SYDNEY NORTH PLANNING PANEL COUNCIL ASSESSMENT REPORT

Panel Reference	PPSSNH-446
DA Number	DA2023/1708
LGA	Northern Beaches
Proposed Development	Demolition works and construction of a Recreation Facility (indoor) with signage
Street Address	Lot 2743 DP 752038, 431 Pittwater Road NORTH MANLY NSW 2100
Applicant/Owner	Ian Hardy Northern Beaches Council
Date of DA lodgement	08/12/2023
Number of Submissions	18 submissions – 16 in support; two (2) objections.
Recommendation	Approval
Regional Development Criteria (Schedule 7 of the SEPP (State and Regional Development) 2011)	Section 2.19(1) and Clause 3 of Schedule 6 of <i>State Environmental Planning Policy (Planning Systems) 2021</i> declares the proposal regionally significant development as: Council related development over \$5 million
List of all relevant s4.15(1) (a) matters	<ul style="list-style-type: none"> • Statement Environmental Planning Policy (Biodiversity and Conservation) 2021 • Statement Environmental Planning Policy (Industry and Employment) 2021 • State Environmental Planning Policy (Planning Systems) 2021 • Statement Environmental Planning Policy (Resilience and Hazards) 2021 • Statement Environmental Planning Policy

Figure 15 - Extract of DA Lodgement Ground Floor Plan

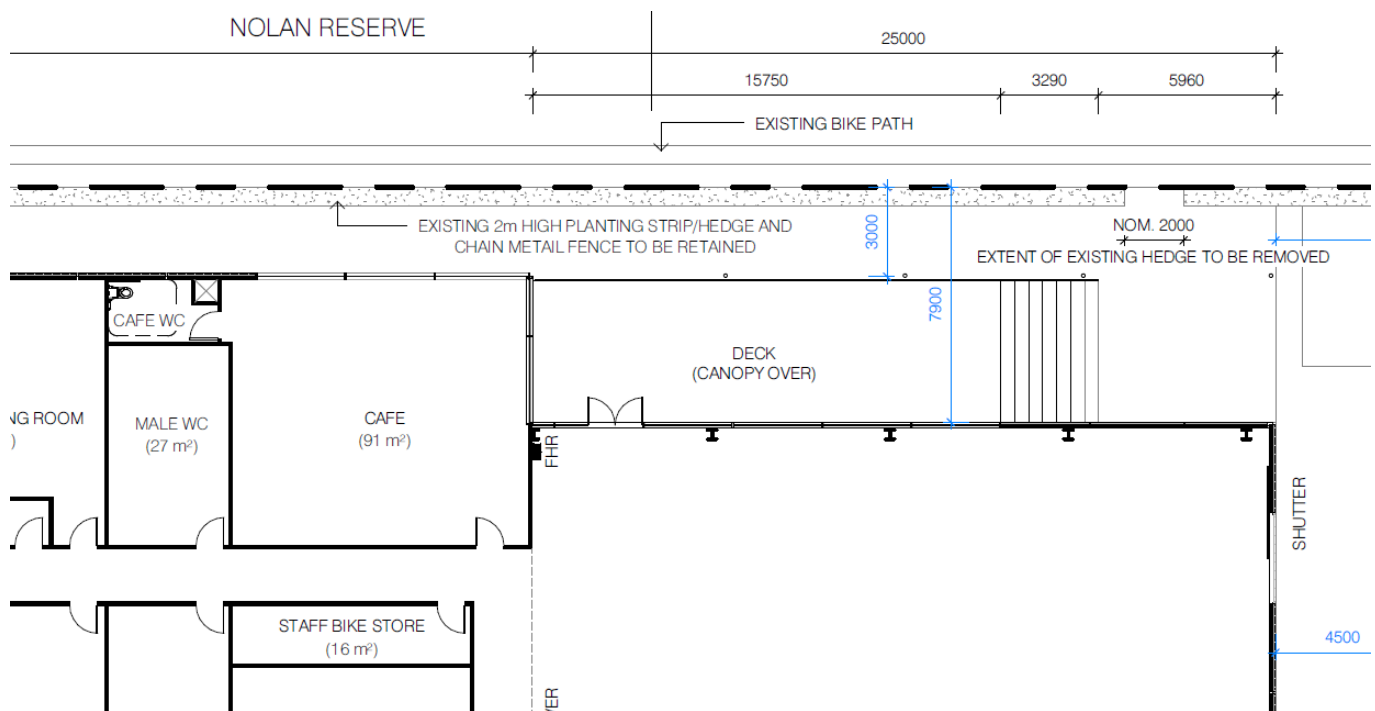
Comment: The café was noted to be located deep within the building, mostly overshadowed and of minimal visibility.

As the plan notes, only a 2m wide segment of the existing hedge was intended to be removed to facilitate connection to the broader public open space. The existing hedge in front of the café would be retained, limiting its visibility.

In response to the request for additional information issued on the application, the applicant amended the interface with Nolan Reserve to remove the current boundary landscaping for the length of the café frontage, increasing the visibility of the café. Further, removing the landscape buffer will substantially increase activation and casual surveillance between the café and Nolan Reserve resolving the main concern over its activation.

The final iteration of the landscape plan submitted proposes new landscaping along the 3m setback of the building to the lease area but will retain a wider opening to ensure visibility and connectivity.

Figure 21 – Lodgement 9am, 12pm and 3pm shadow diagrams

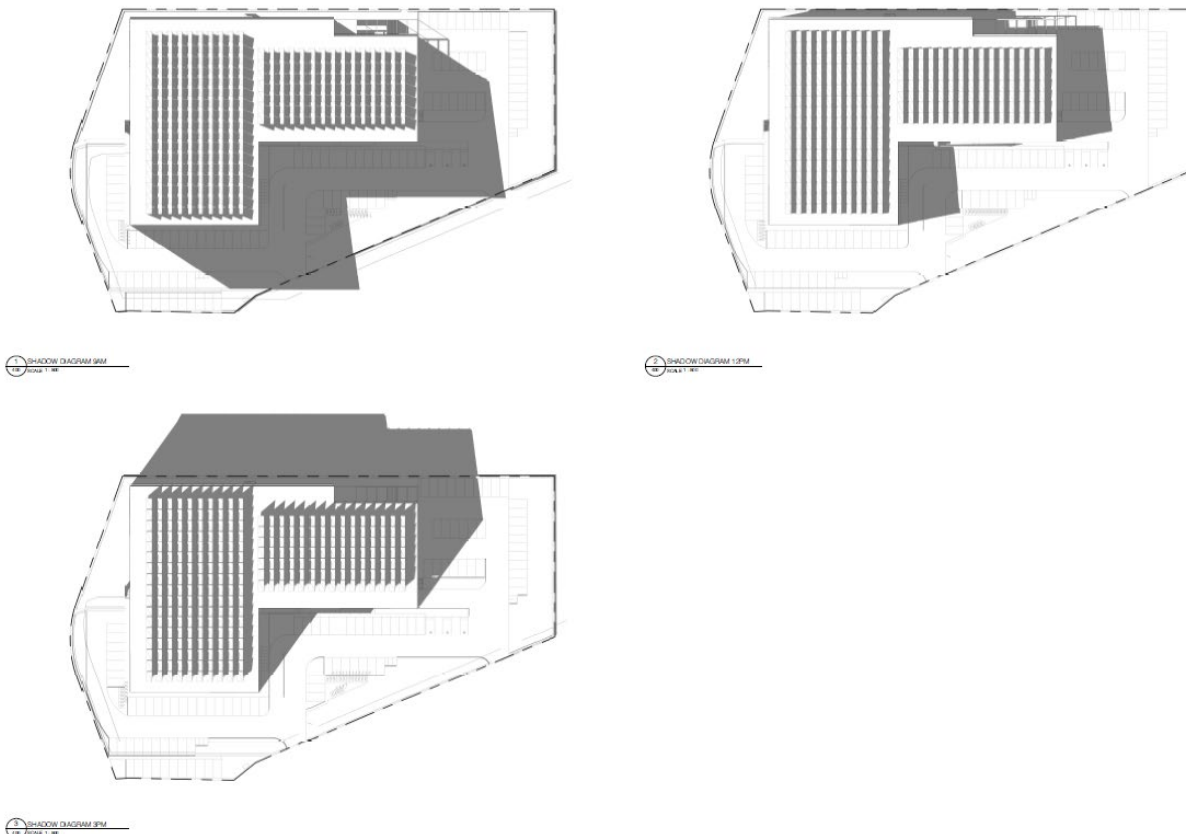
The initial referral response raised concerns with the impact to Nolan Reserve, located to the top of the image. The 3pm shadows (the bottom of the plan) indicate some level overshadowing falls onto Nolan Reserve (and the share path, which borders the site). However, the impact was not clear due to limited

A request for additional information was issued regarding further detail on the overshadowing impact. The location of the field where the Manly Brothers Rugby League Football Club play during winter was provided to the applicant and the distance ground truthed by the applicant and supplied in amended shadow diagrams. Hourly shadow diagrams were requested for the afternoon.

It was also raised that the Manly Brothers typically play around 3pm to 4:30pm. Accordingly, it was requested for 3:30pm, 4pm and 4:30pm shadow diagrams to be prepared.

Figure 22 – 1pm, 2pm, 3pm, 3:30pm, 4pm and 4:30pm shadow diagrams on June 21

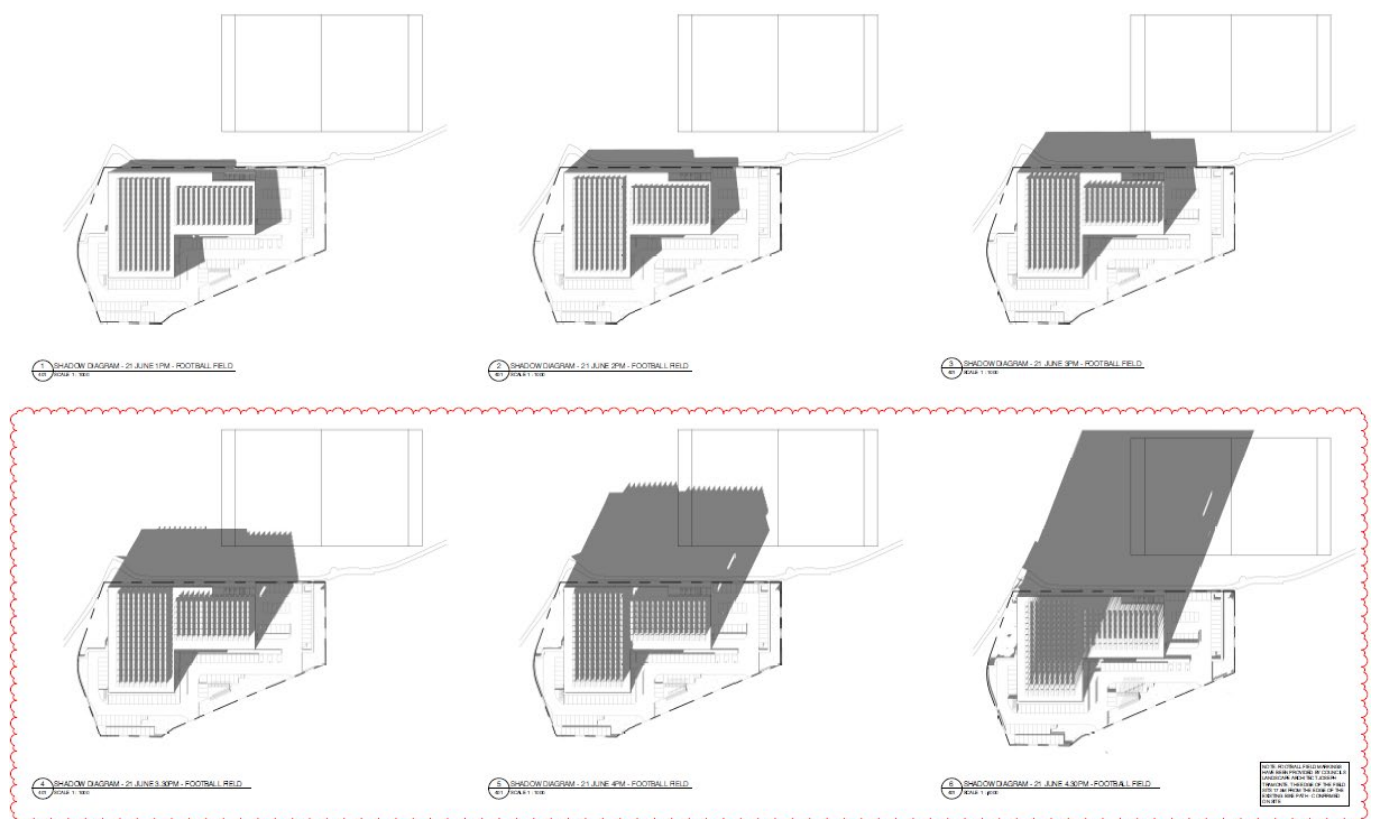
As the diagrams illustrate, the sideline on the northern end of the field will be marginally affected at 3pm, with the impact increasing to 4:30pm where almost half the field will be overshadowed. The latest referral comments were issued on these diagrams.
